HALCYON LAKE ESTATES PHASE 1

Part of the SW Quarter of Section 21, Township 6 North, Range 2 West, S.L.B&M.
Weber County, Utah
3 June, 2019

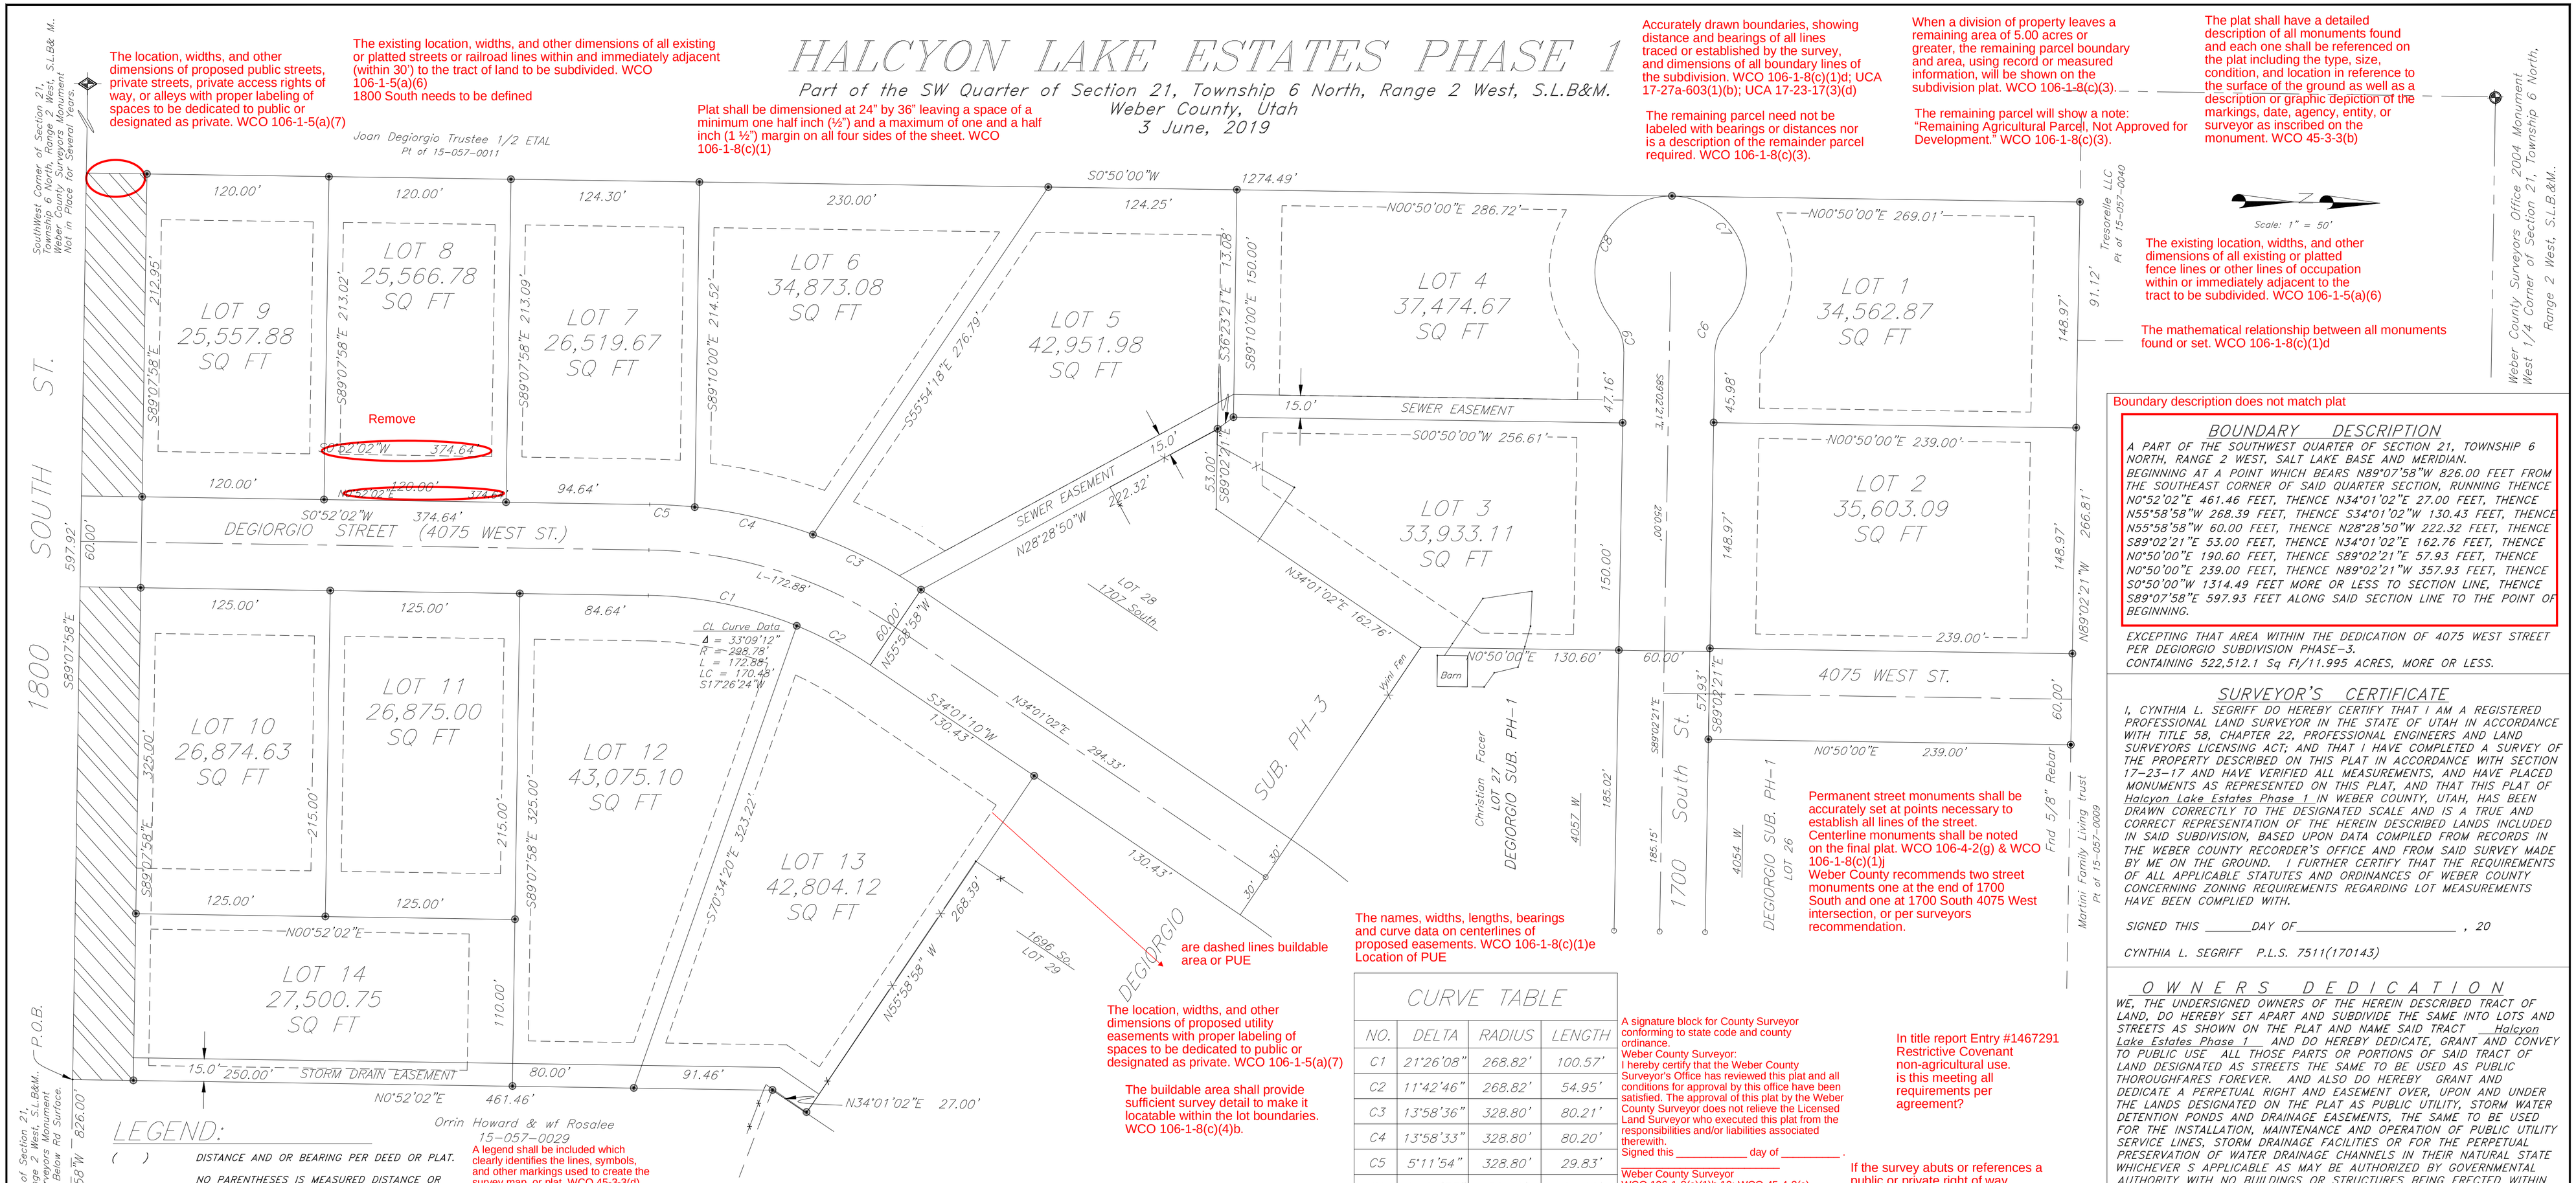
The existing location, widths, and other dimensions of all existing or platted streets or railroad lines within and immediately adjacent (within 30') to the tract of land to be subdivided. WCO 106-1-5(a)(6)
1800 South needs to be defined

Boundary description does not match plat

Permanent street monuments shall be accurately set at points necessary to establish all lines of the street.
Centerline monuments shall be noted on the final plat. WCO 106-4-2(g) & WCO 106-1-8(c)(1)j
Weber County recommends two street monuments one at the end of 1700 South and one at 1700 South 4075 West intersection, or per surveyors recommendation.

A legend shall be included which clearly identifies the lines, symbols, and other markings used to create the survey map, or plat. WCO 45-3-3(d)
Missing pue or building setback
dashed lines 1700 south street dedication

are dashed lines buildable area or PUE

The names, widths, lengths, bearings and curve data on centerlines of proposed easements. WCO 106-1-8(c)(1)e
Location of PUE

In title report Entry #1467291 Restrictive Covenant non-agricultural use. is this meeting all requirements per agreement?

Who will be signing

SIGNED THIS ____ DAY OF _____, 20 use new signature block

distance needs to be labeled
